Request for additional information - Proposed staged subdivision

DA 8/2016/557/1 - Wine Country Drive, Rothbury

Enc: Appendix A - Hydraulic Category Plan

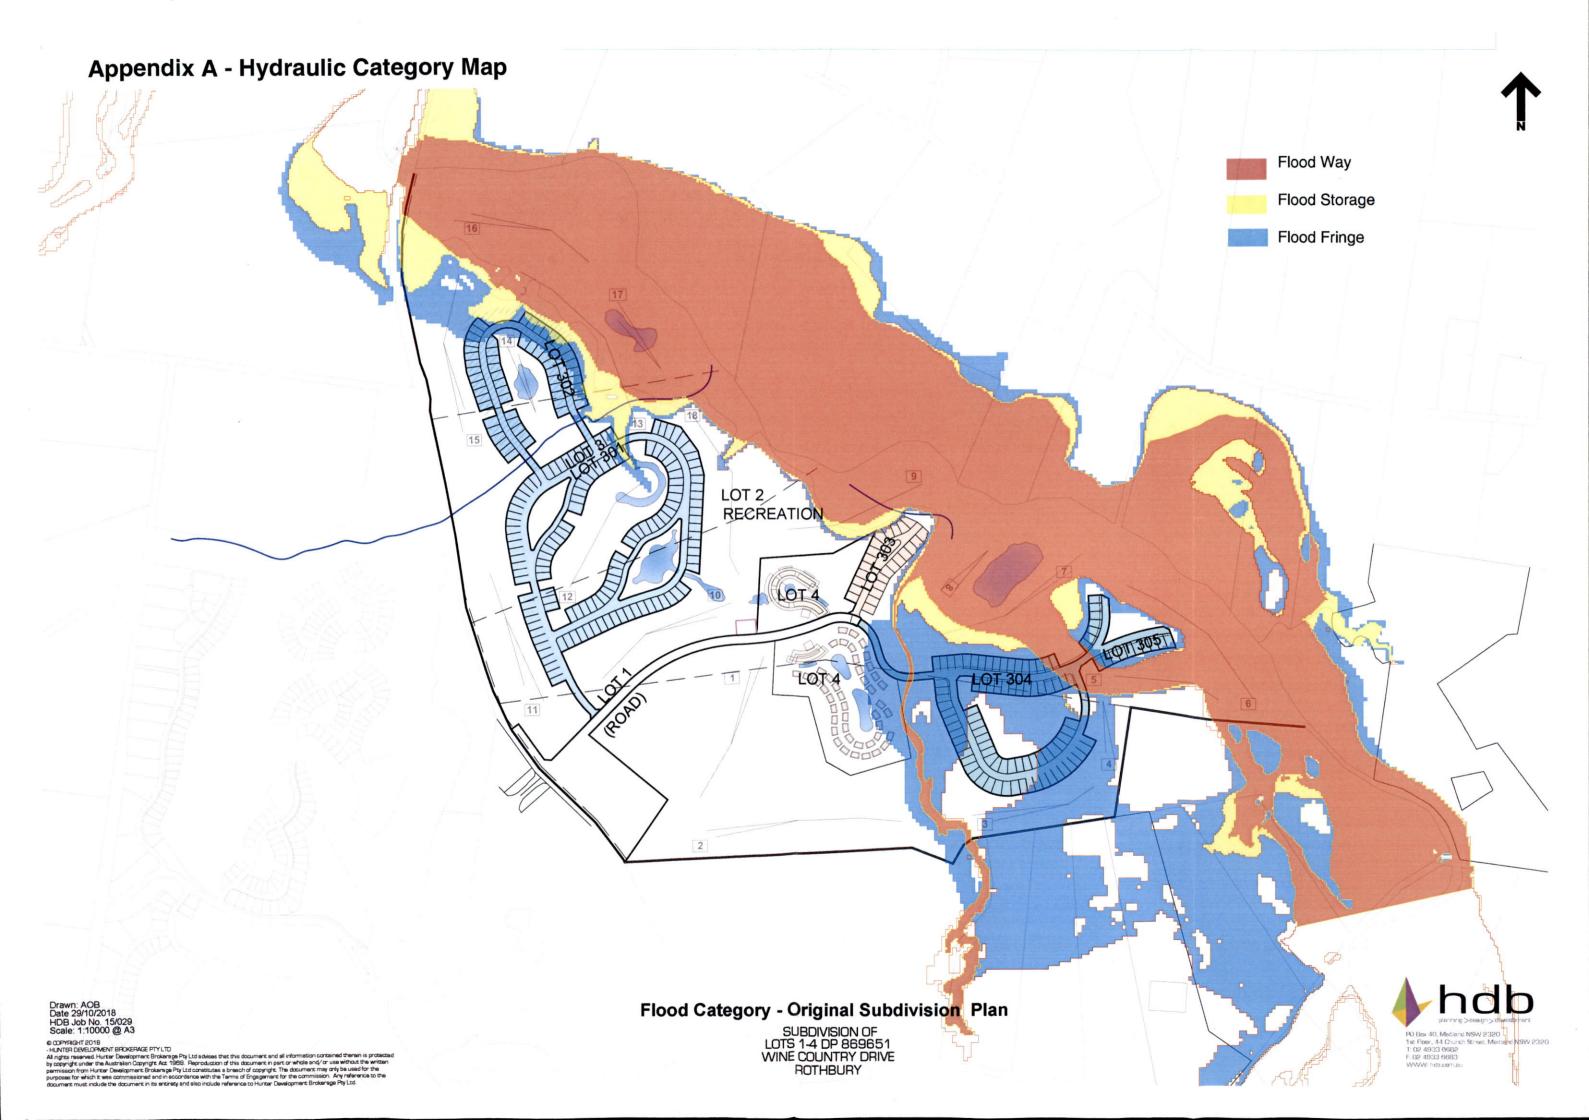
The recently adopted *Black Creek Stage 2 Flood Study* identifies that some of the residential allotments proposed under DA 8/2016/557/1 are within the 'flood way' as defined by Black Creek Hydraulic Category map (**Appendix A**). As such, Council officers advised that the concept master plan should satisfy Cessnock DCP, *Part C, Chapter 9* requirements for development on flood prone land.

As shown on the enclosed *Flood Category Map* (Appendix A), only 4 residential allotments were affected by the defined 'flood way'.

Appendix B - Proposed amendments to the concept master plan

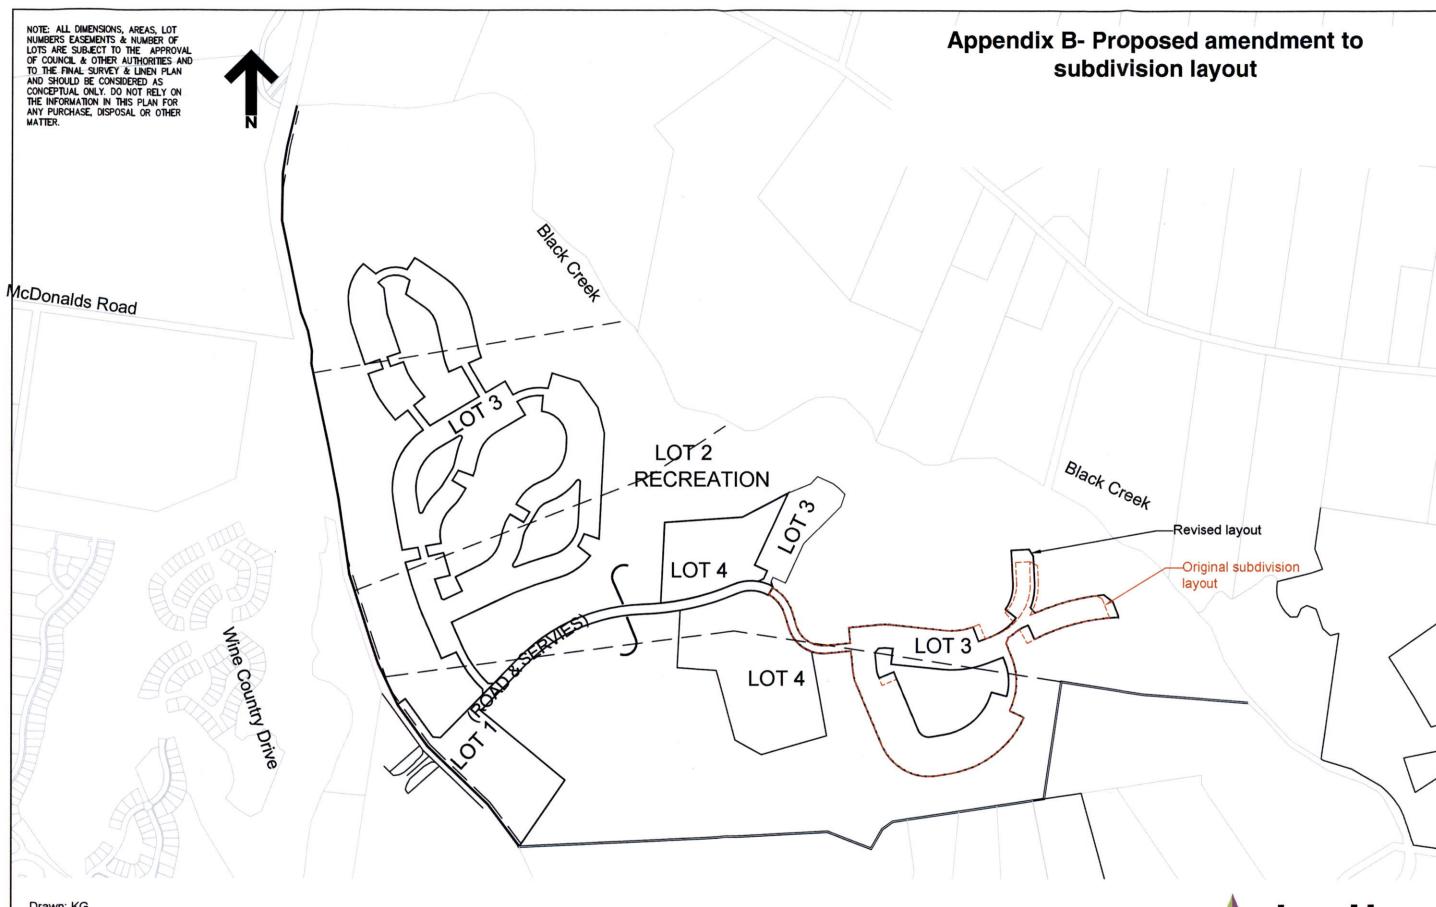
A minor lot-adjustment is proposed for that part of the Concept Master Plan to relocate some allotments to a flood-free area. As previously advised, it is also proposed to fill a section of this land to raise the road level along with a suitably designed box culvert so that all allotments will be safe from flood risk. Refer to enclosed *Appendix B* showing the amended lot layout.

Appendix C - Revised Plan of Subdivision

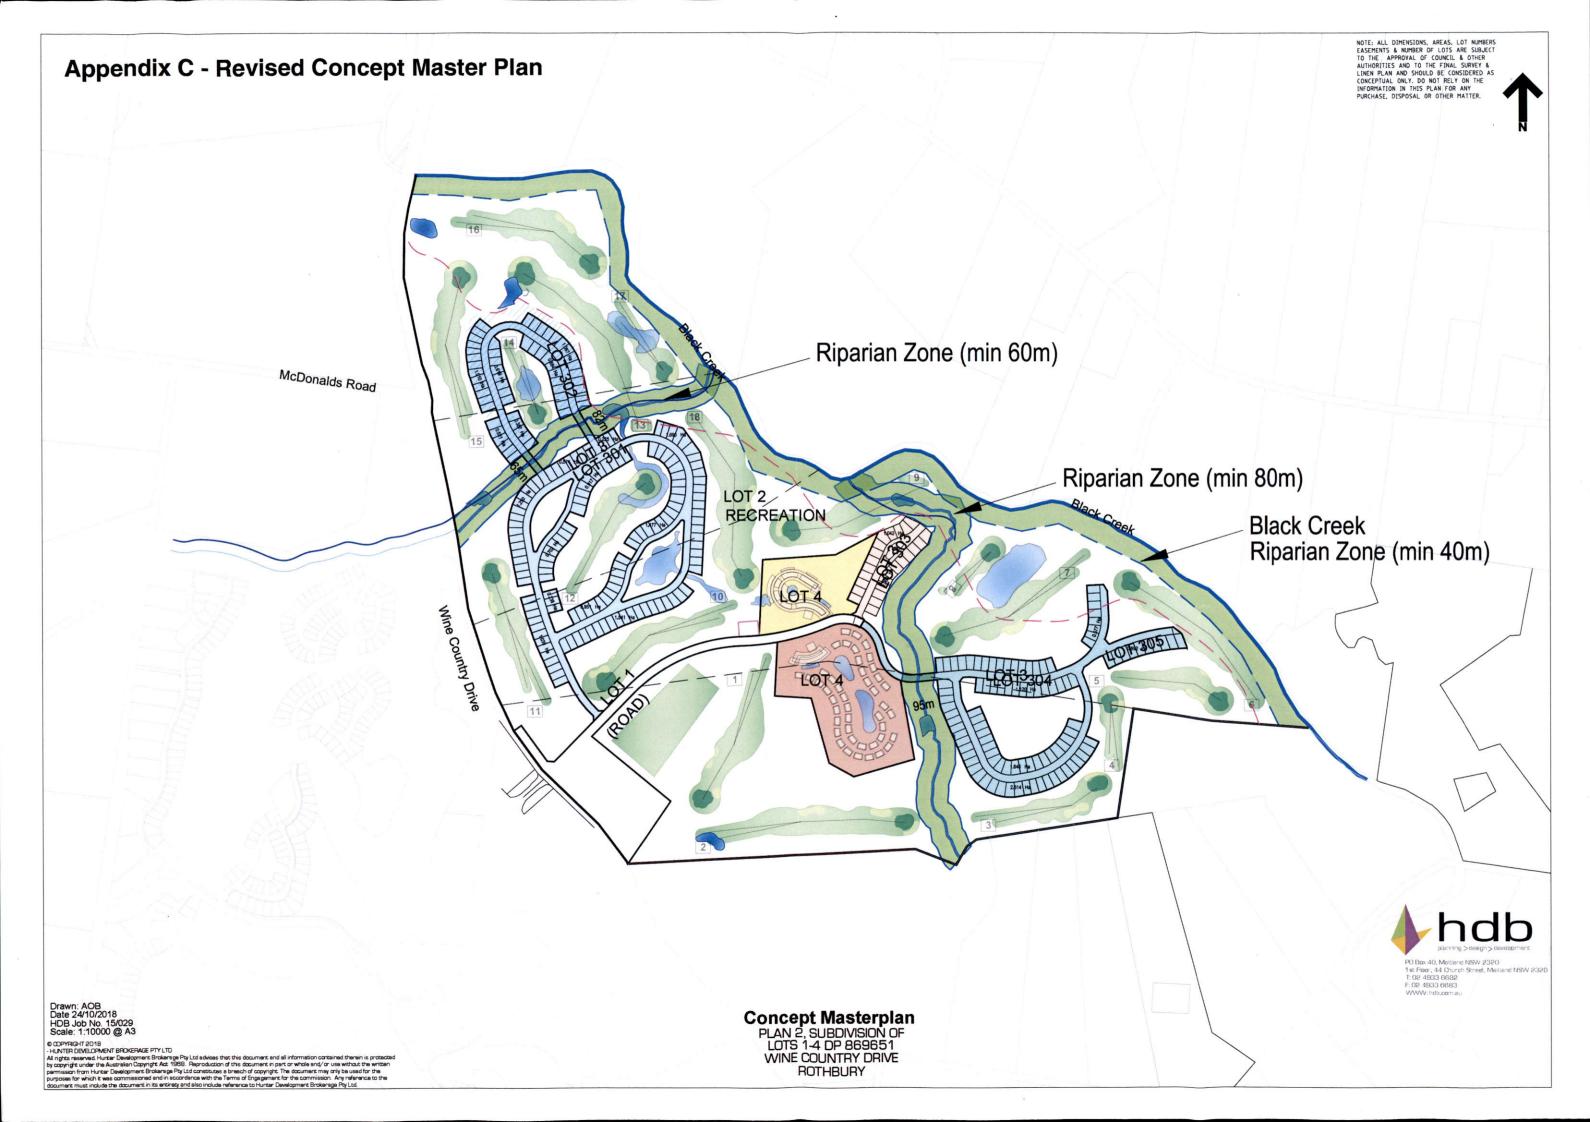
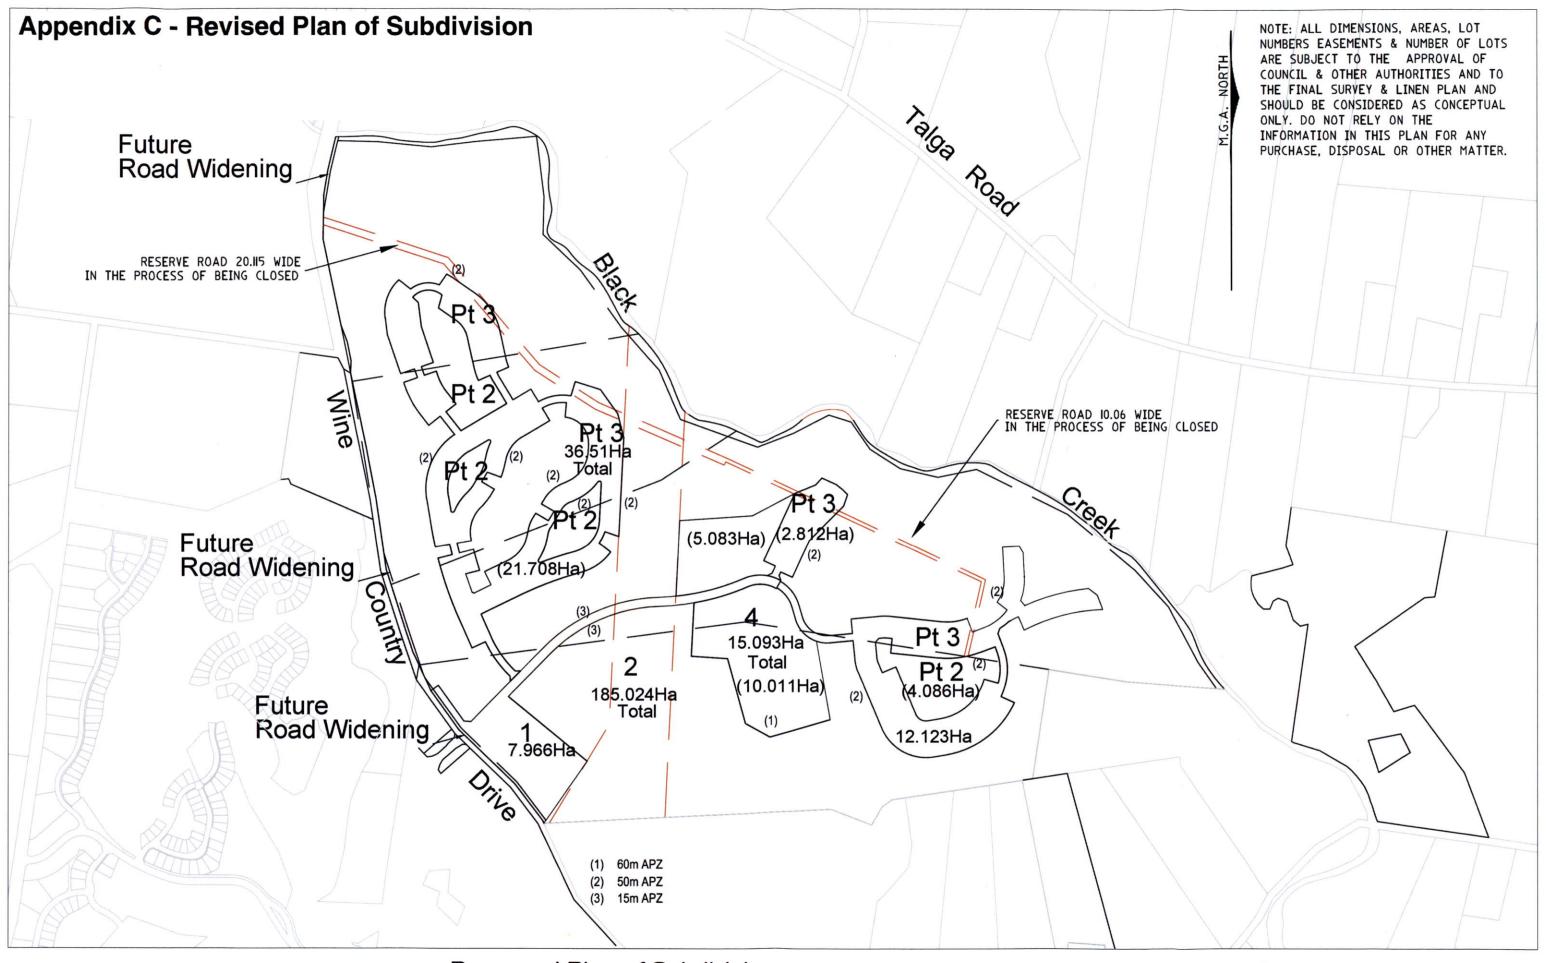
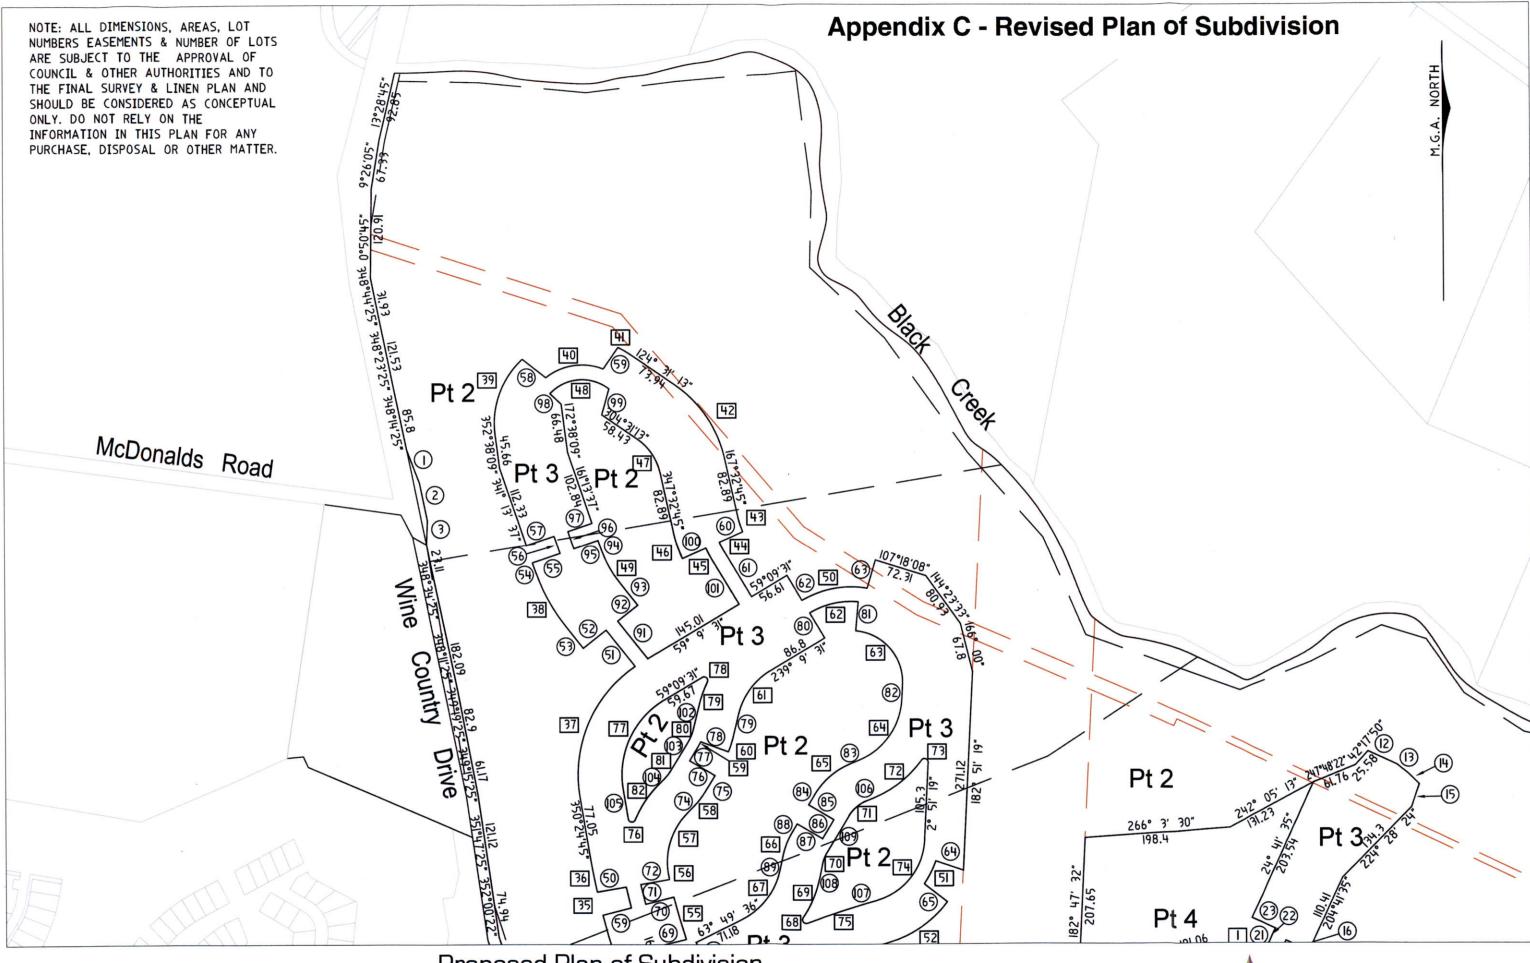
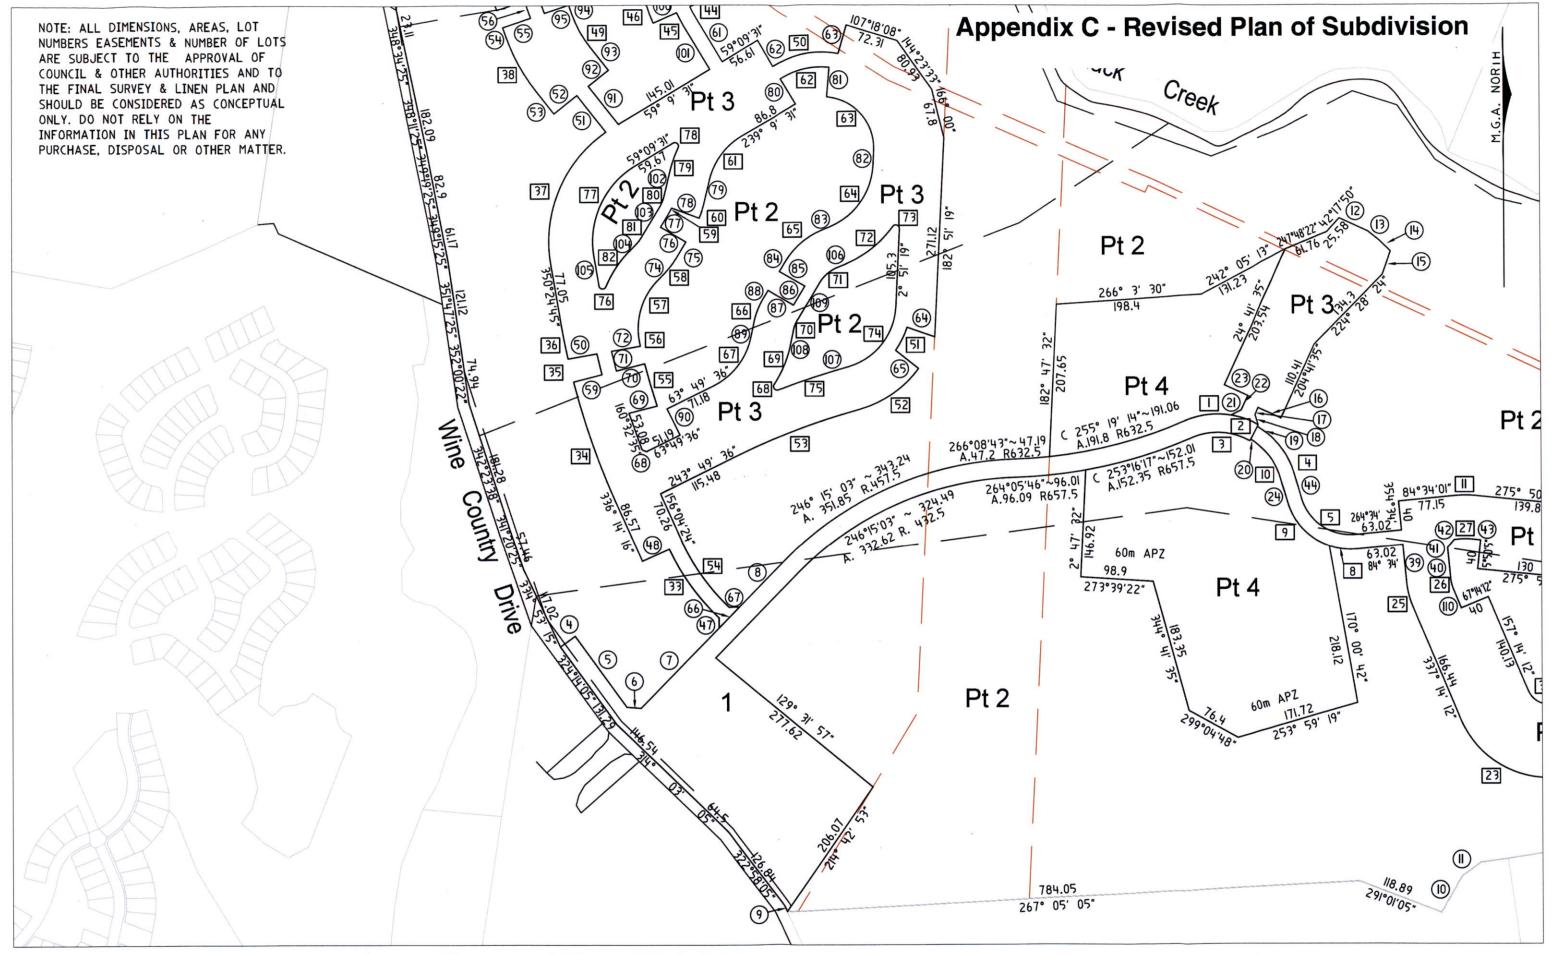
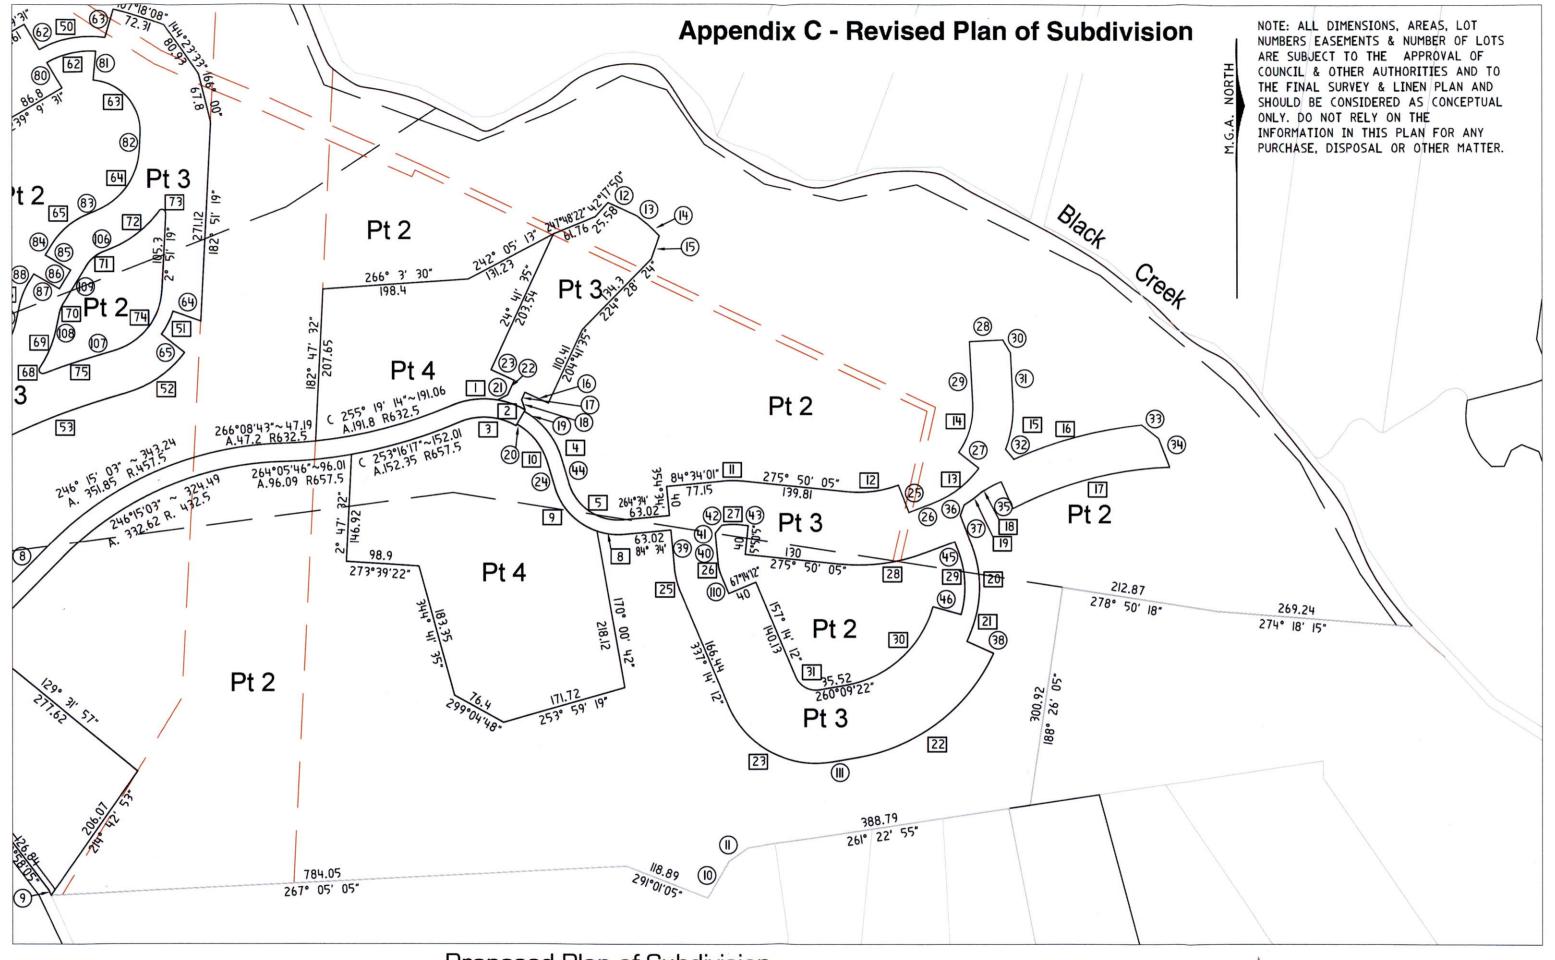
- i. Revised Concept Master Plan, dated 24/10/2018 reflecting the amended subdivision layout;
- ii. Revised Plan of Subdivision, dated 24/10/2018 reflecting the proposed amendments to the super lots; and
- iii. Revised subdivision plan with overlaid Flood Category.
